ADDENDUM 01

Project Title: **Blinn Mechanical Project – Brenham – Melcher + BCPA Phase 2**
RSE Project #: **1540**

This **ADDENDUM** shall modify, amend, extend and become a part of the Contract Documents dated 1/13/25 prepared by Ramirez Simon Engineering, LLC (RSE) in accordance with the terms therein, as if written out in full therein and bound originally therewith.

ELECTRICAL
MELCHER
FLOORPLAN

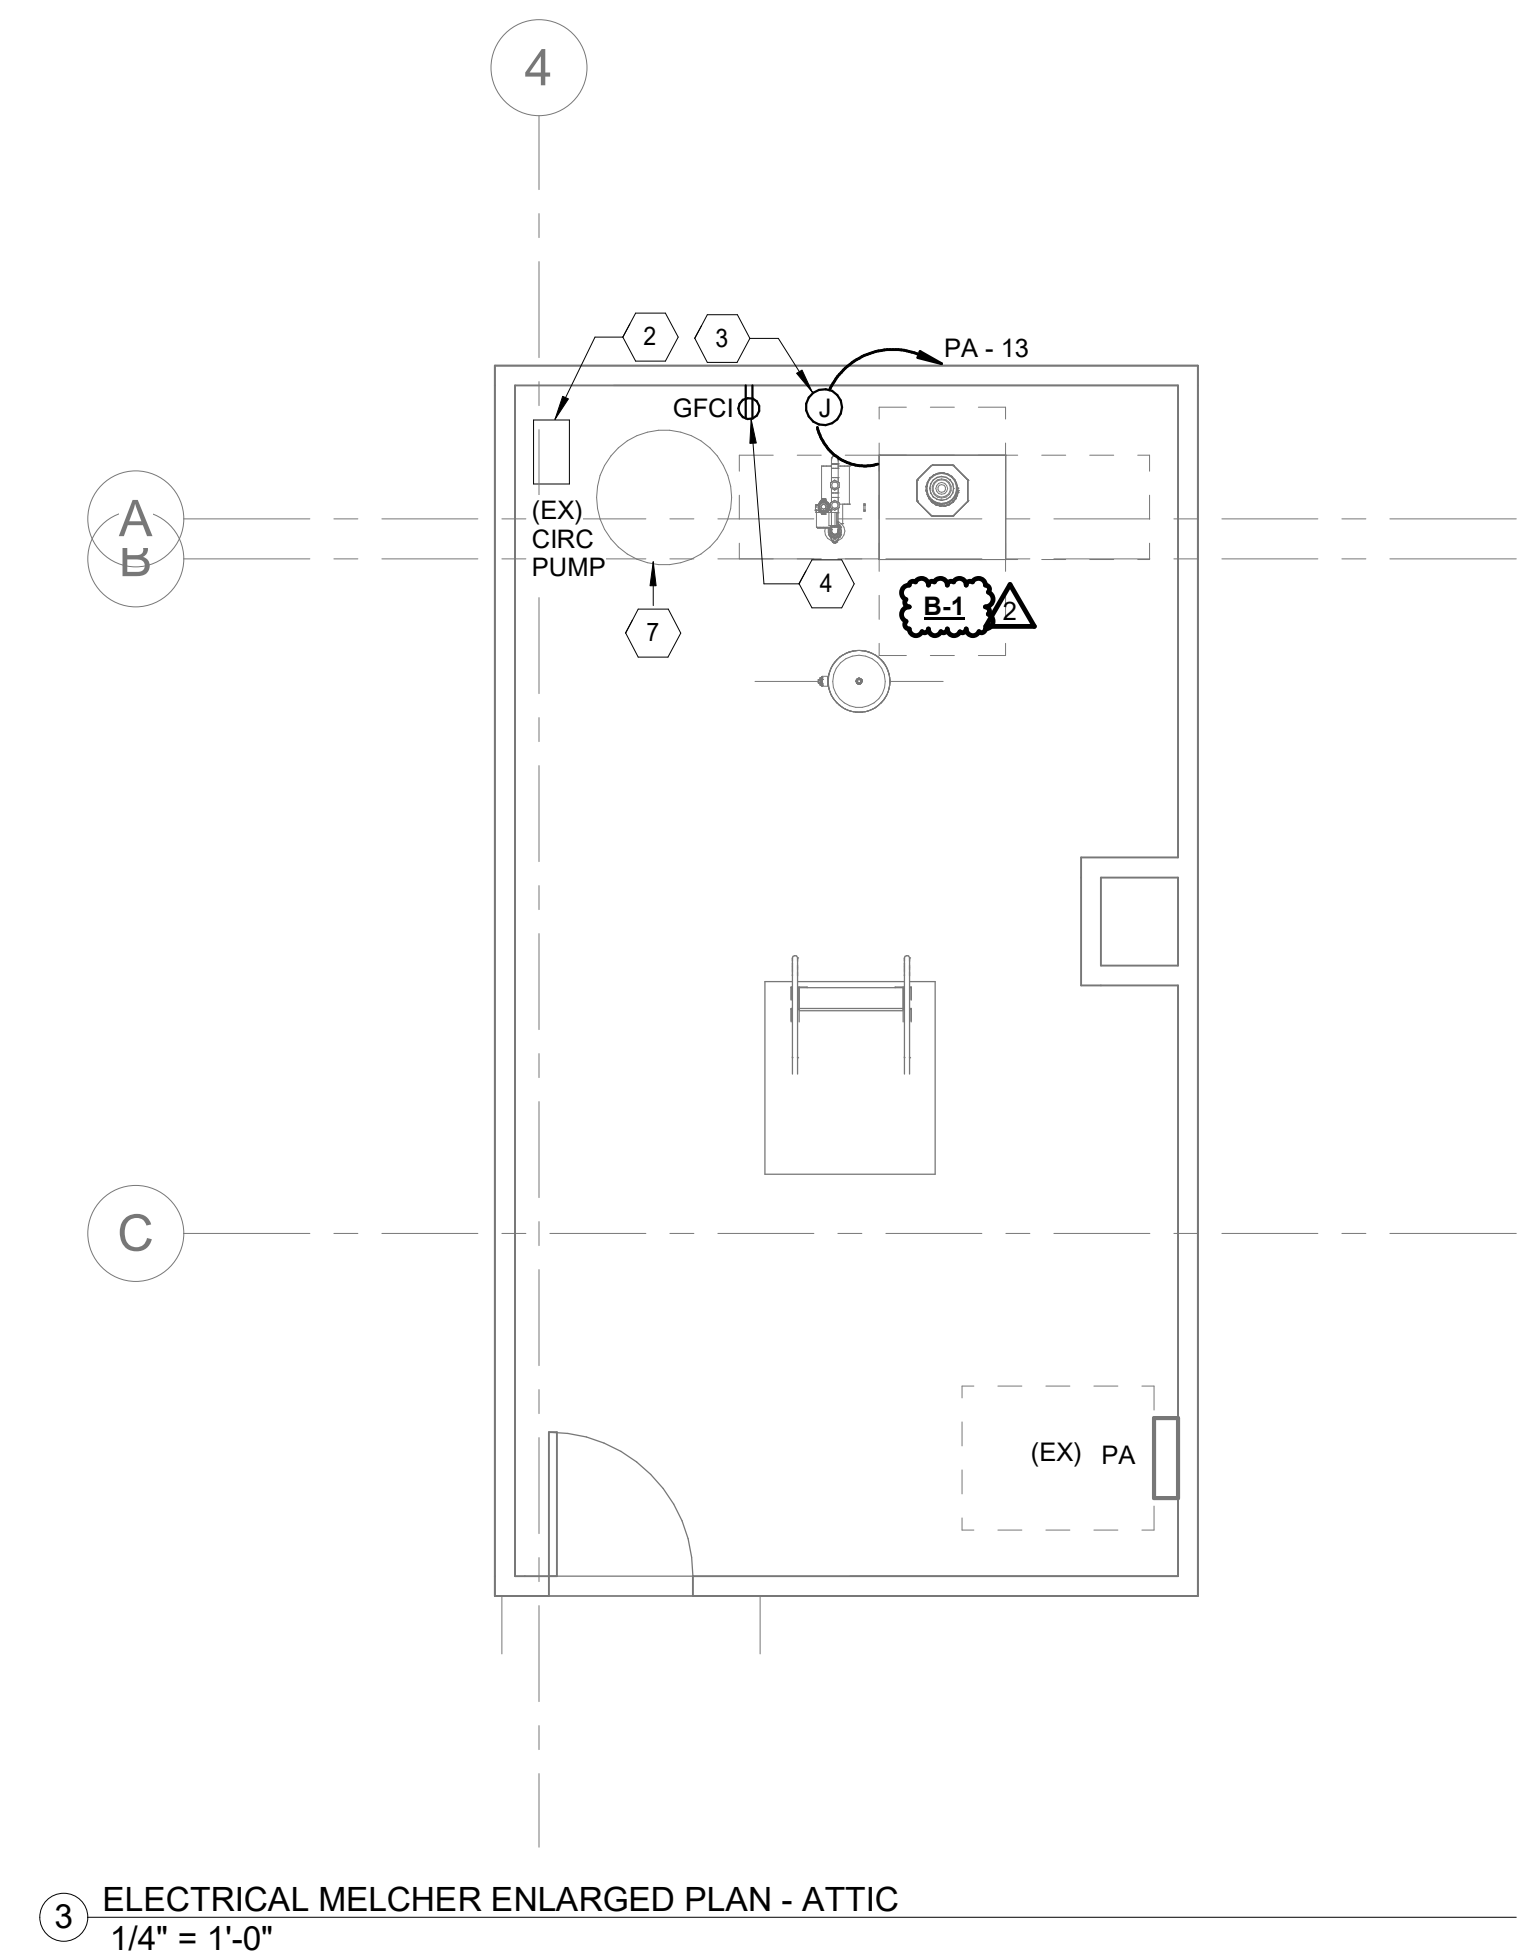
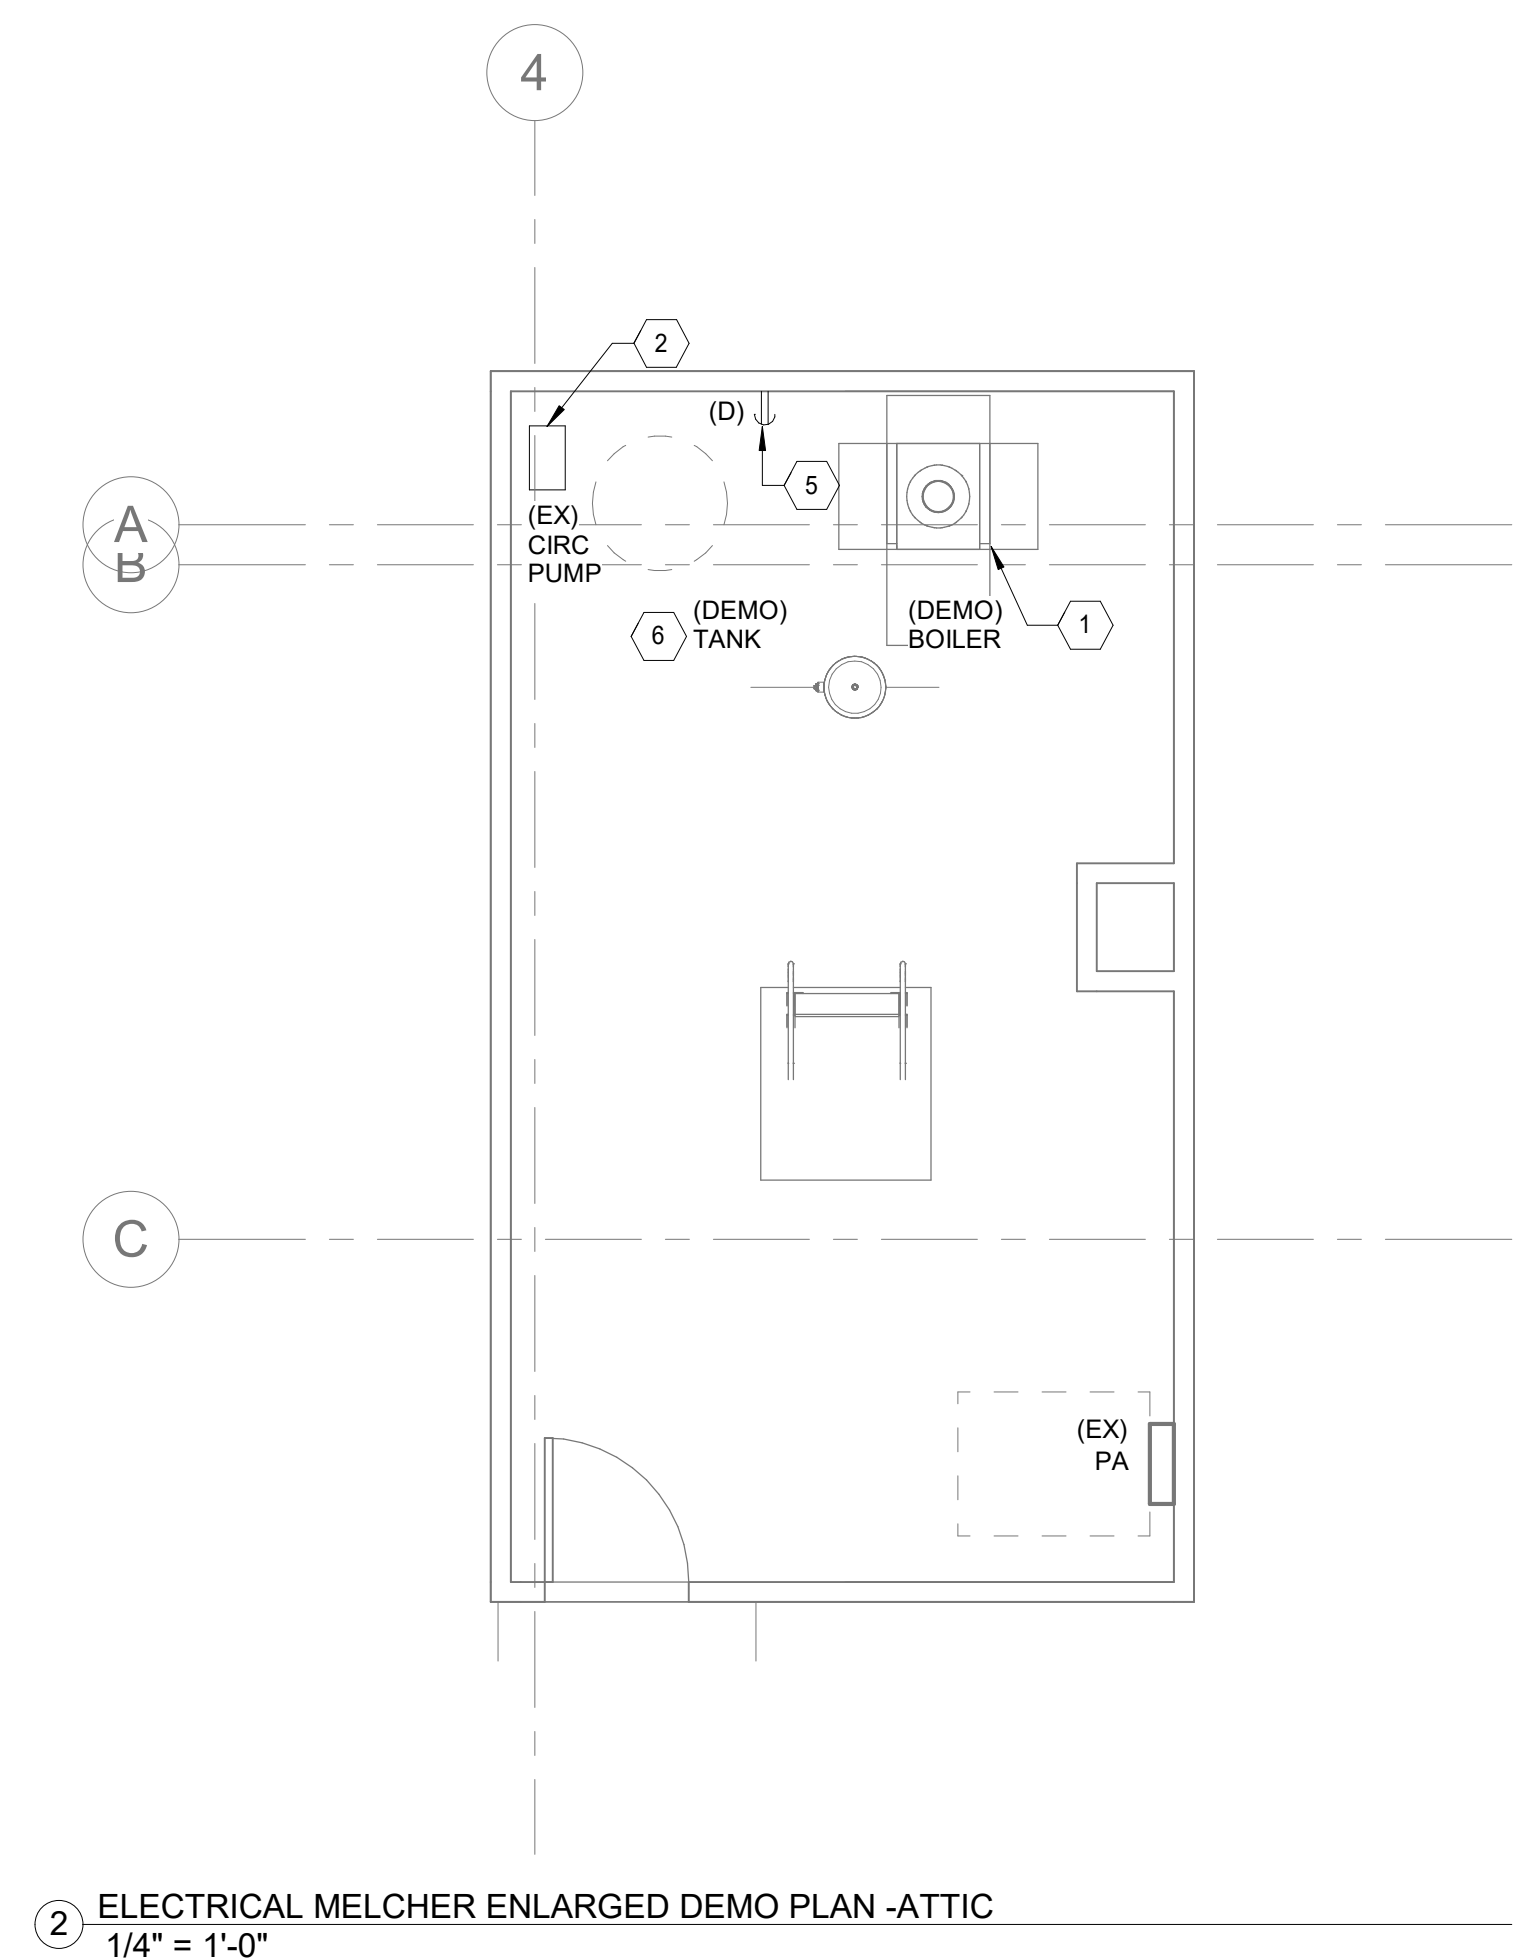
1. E301-ELECTRICAL MELCHER FLOORPLAN
 - a. Updated Fixture Tag from B-3 to B-1 for new boiler.
